CONFIDENTIAL PROPERTY OF ALLIS-CHALMERS MFG. CO.		NAME CIRCULATING OIL SYSTEM - PIX	
3005 - M / PLANT		DATE	
UNLESS OTHERWISE SPECIFIED			
1. PLACE DEC. 4	ANGULAR	✓	FINISH
2. PLACE DEC. 4	E		
FOR TOLERANCES NOT SPECIFIED SEE 100 SERIES SHOP PRACTICE STANDARDS		WELDING	TEXTURE
DR RD 11-13-69	DES 4-2-531	BY	CHKD
CH IAP 11-2-69	DES 4-2-531	BY	CHKD
AP 4-25 2/11/69	NTS	FINAL	NO
05-416-993-402		05-416-993-402 (T)

8004220447
 Attachment 4

ORIG. BY RD APPRD. IAP RGH. WT. FIN. WT. CAT. NO. PARENT ASSEMBLY NAME CIRCULATING OIL SYSTEM SHEET NUMBER 1-

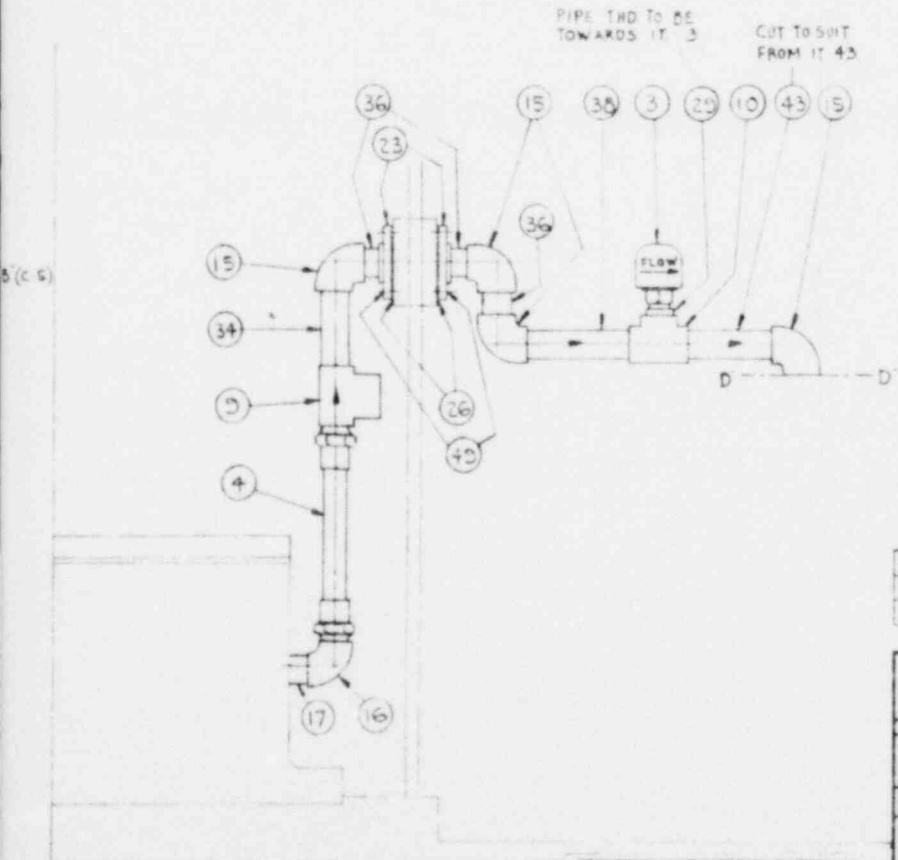
11-21-69
 VIEW "F" ADDED
 ITEMS 46, 47, 53 ADDED
 EFF 2-0509-38822
 2-0509-38823
 2-0509-38824
 2-0509-38825
 02 2-4-70
